**RE: WAMBO COAL MONTROSE EAST UNDERGROUND MINE MODIFICATION – DA 305 – 7 -2003
MOD 10**

Review of Environmental Assessment

Wambo Coal Montrose East Underground Mine Modification

Re: Wambo Coal development consent modification (DA 305-7-2003 Mod 10) – Montrose East Underground

Figure 1 – Overlay of A444 and ML 1572

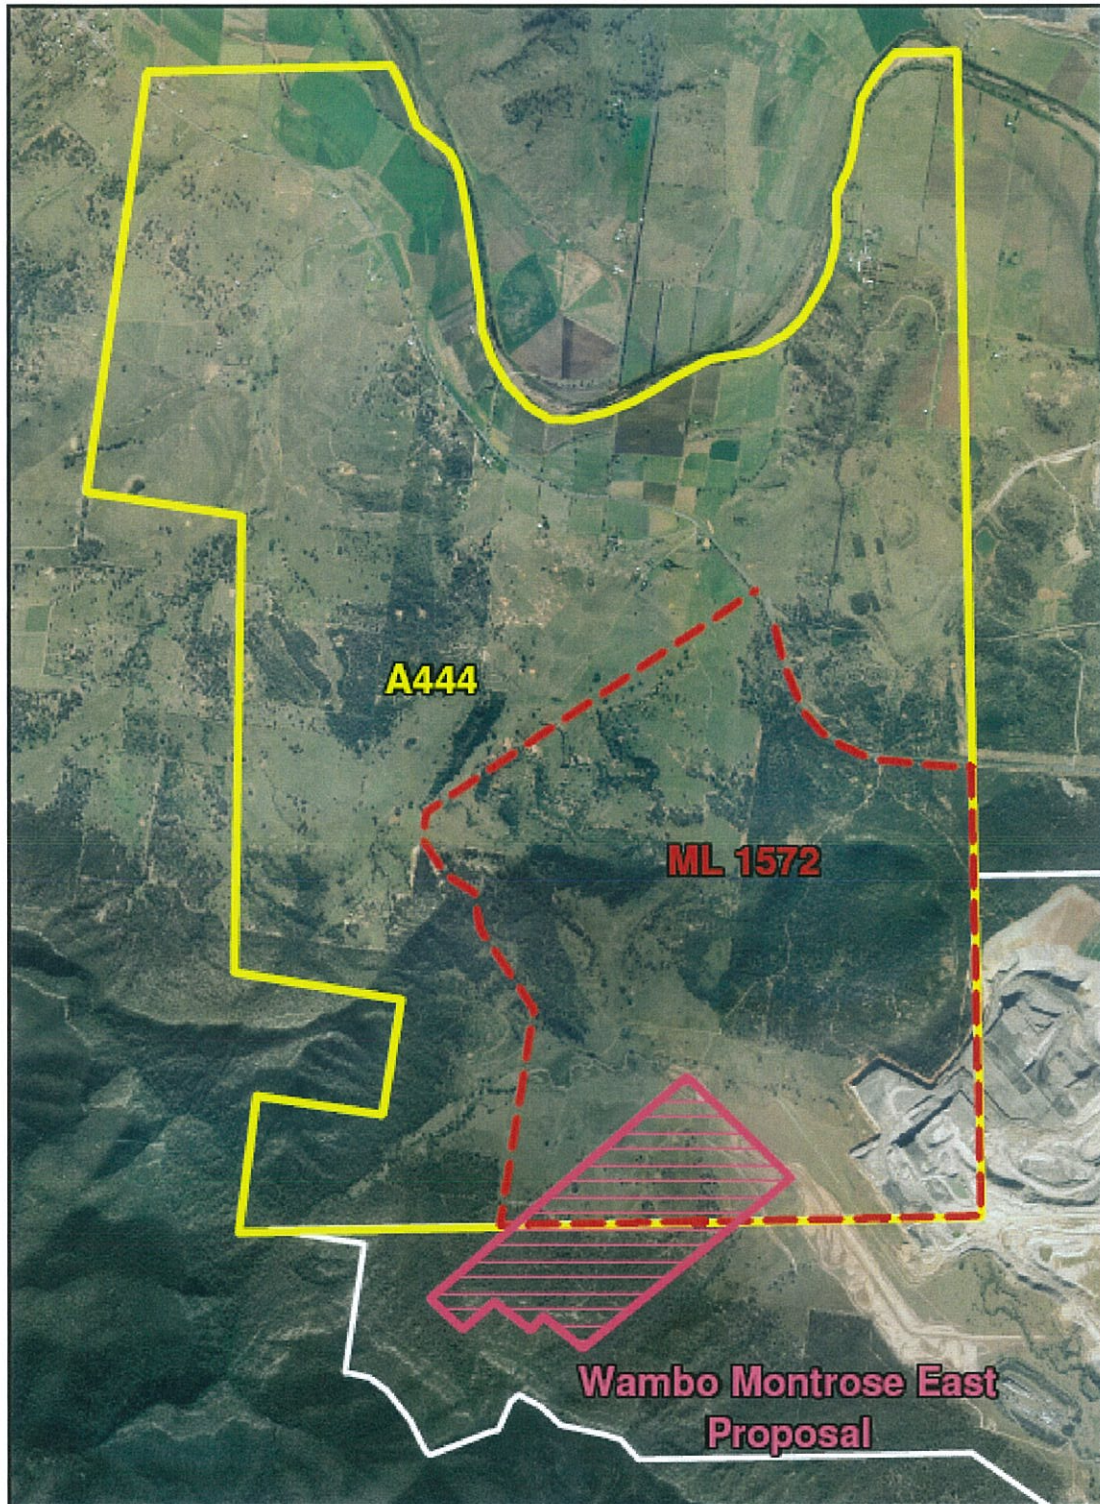
Figure 1 shows the A444 Exploration Authorisation (A444) held jointly by Wambo and the Construction, Forestry, Mining and Energy Union (CFMEU). The CFMEU are a joint venture partner in United and its interest in the A444 tenement is held by the CFMEU on behalf of the United Joint Venture.

ML 1572 (which covers the surface to the Whynot Seam) was excised from A444 in 2003. However A444 remains in existence for the seams below the Whynot to 5m above the Bayswater seam, which are assigned to United by way of commercial arrangements between Wambo and United.

The EA does not contemplate the existence of the Exploration Authorisation or any impacts that may arise through the establishment of infrastructure and/or mining of the Proposal on A444 or its joint holders.

United will be undertaking works to ascertain the impacts on its commercial arrangements with Wambo, its interests in the stratified tenements in the area and the future resource recovery for United in A444. United requests that Wambo and The Department of Planning and Infrastructure (the Department) continue to liaise with United throughout the assessment period as to the extent of any impacts the Proposal may have on United's interest in A444 such as, but not limited to, temporary or permanent sterilisation of resources.

Figure 2 – Overlay of CL 397, ML1594 and CCL 775

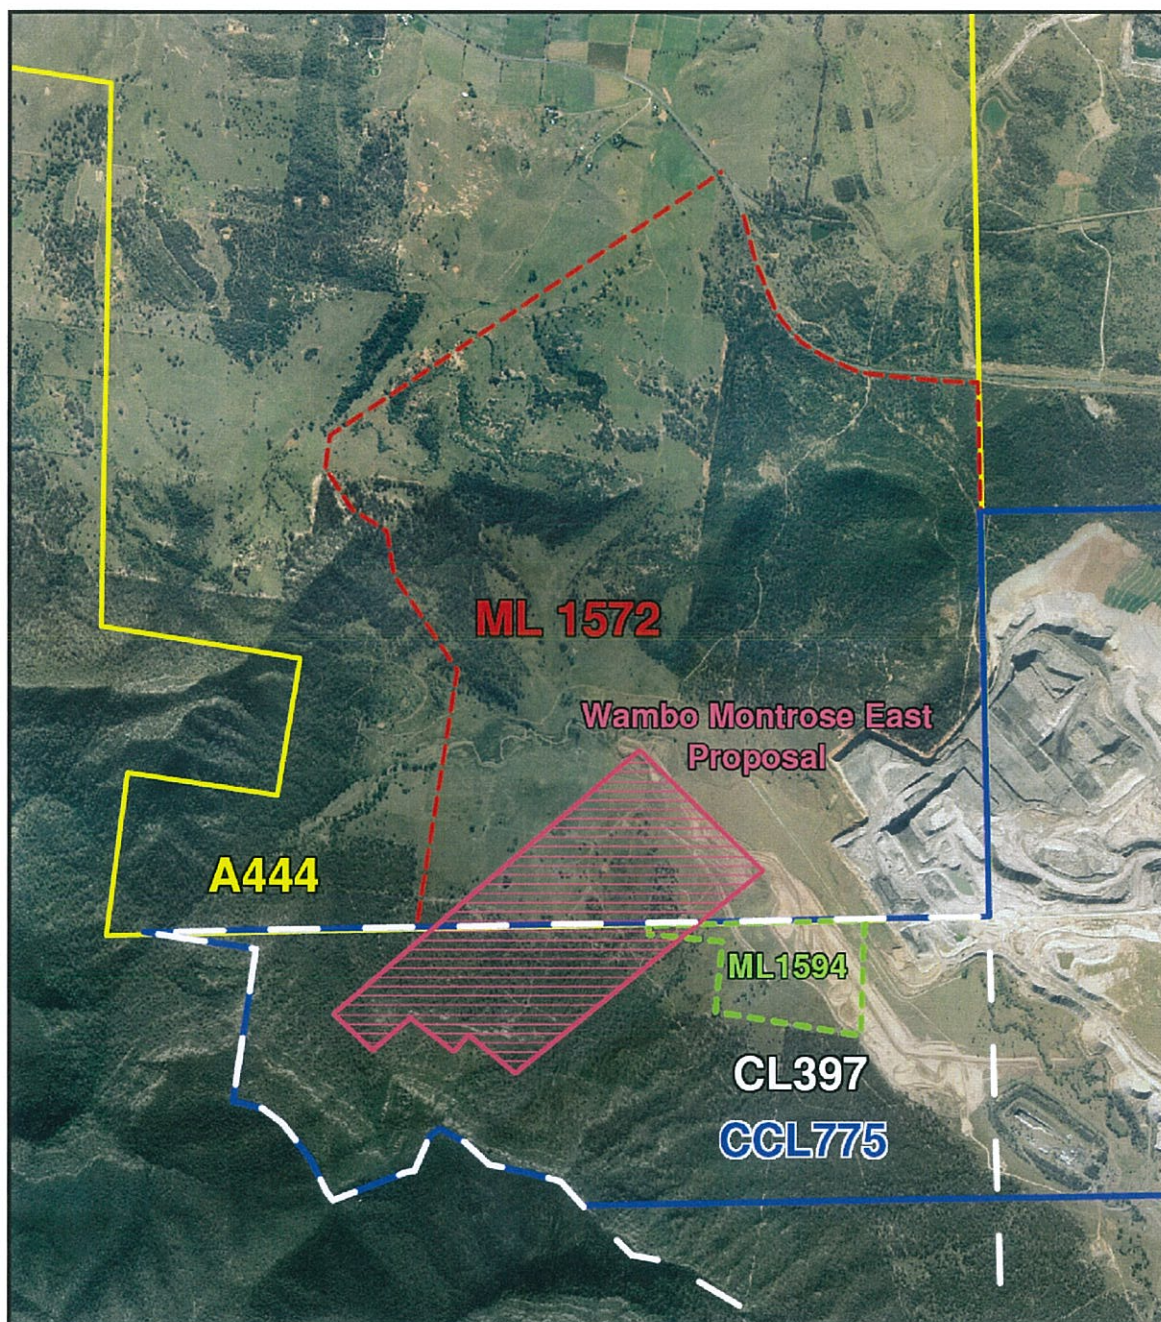
Figure 2 shows Wambo mining tenements CL397 and ML1594 overlaid with Consolidated Coal Lease CCL775 held by the CFMEU for United. CCL775 includes the Woodlands Hill Seam which lies beneath the proposed MEU in the Whybrow Seam

The EA does not contemplate the existence of CCL775 or any impacts that may arise through the mining of the Proposal on CCL775 or its holders.

United will be undertaking works to ascertain the impacts on its commercial arrangements with Wambo, its interests in the stratified tenements in the area and the future resource recovery for United in CCL775. United requests that Wambo and the Department continue to liaise with United throughout the assessment period as to the extent of any impacts on CCL775 such as, but not limited to, temporary or permanent sterilisation of resources.
